**SUBJECT: Change Order No. 2 – W-23-7 – 42 Inch Water Main Phase 3 Mound Avenue to Main Street**

Re: REBID 01-24 42-inch Transmission Water Main Phase 3 - Mound Avenue to Main Street  
Change Order No. 2 Summary  
Project W-23-7, Segment 3.33

Change Order No. Two (2)

42 Inch Water Main Phase 3 Mound Avenue to Main Street  
Racine, WI

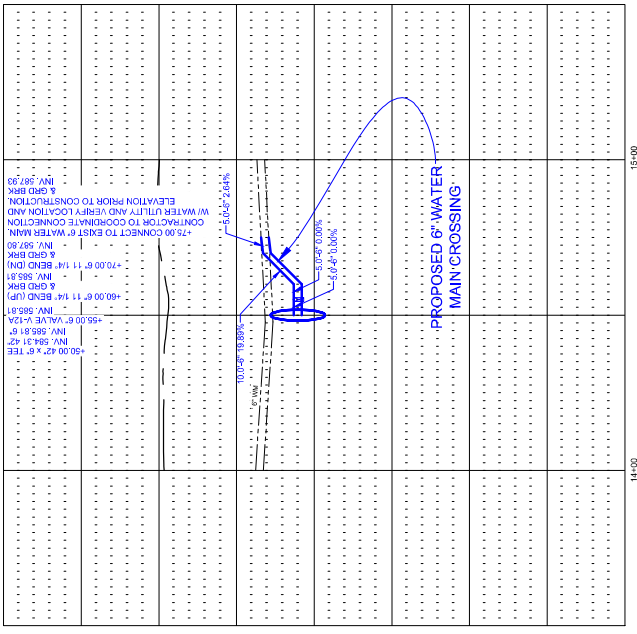
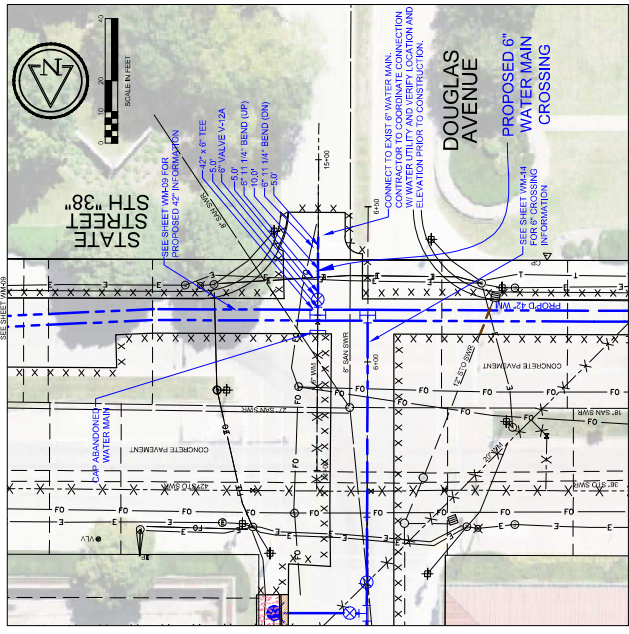
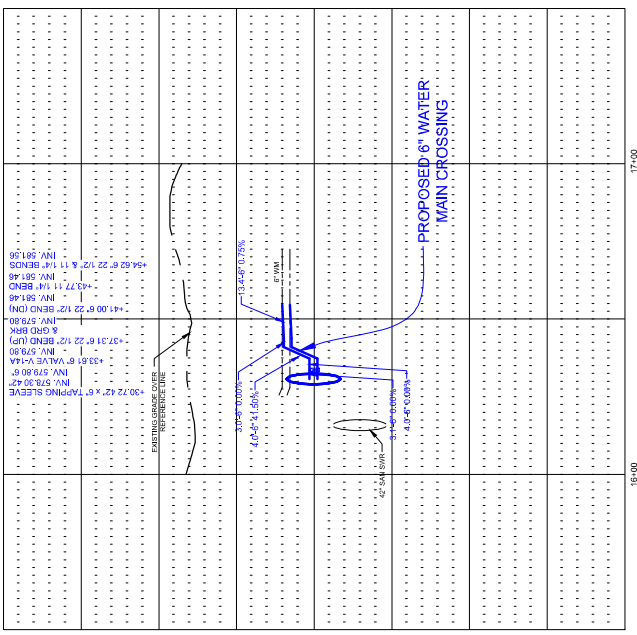
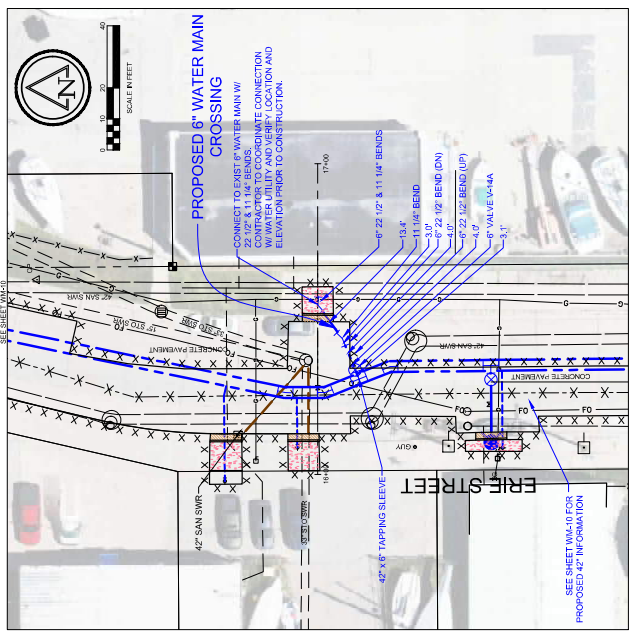
Description:  
Construct new 42-inch diameter water main along Erie Street in accordance with the attached revised drawings and Phasing Plan.

- Attachments:
1. Attachment A to Work Change Directive No 5 and Work Change Directive No. 6.
  2. Sheet WM-10R-1-A and Sheet WM-16R-1 stamped and dated July 15, 2025.
  3. Phasing Plan Sheet dated July 15, 2025.
  4. Price Proposal from Super Excavators, Inc. dated July 28, 2025 and revised on August 6, 2025.

PHASING PLAN

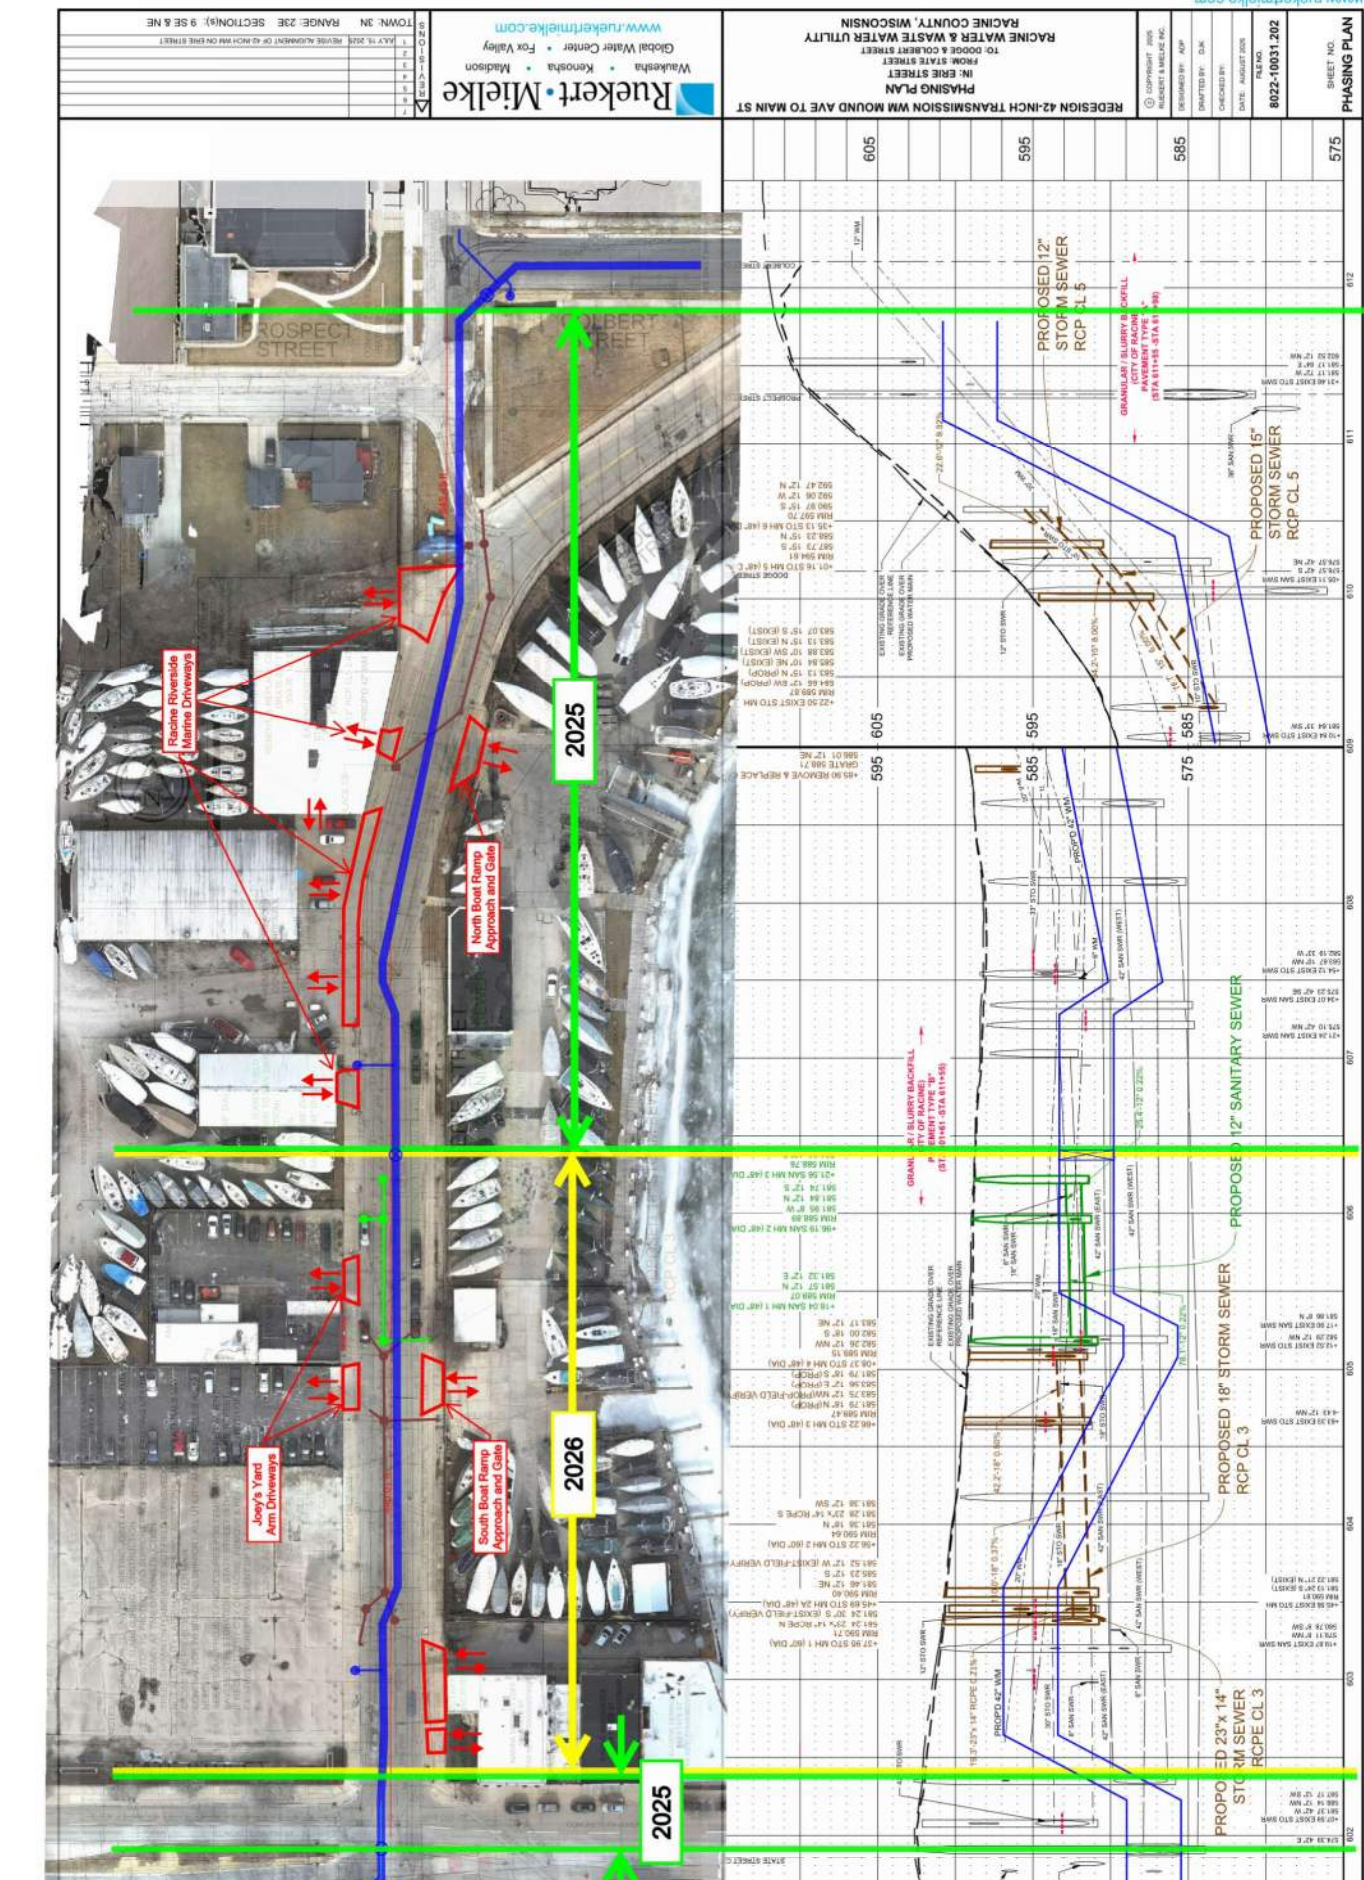
Work on Erie Street shall be split into two phases with construction of the first phase in 2025 and construction of the second phase in 2026 in accordance with the attached Phasing Plan drawing.
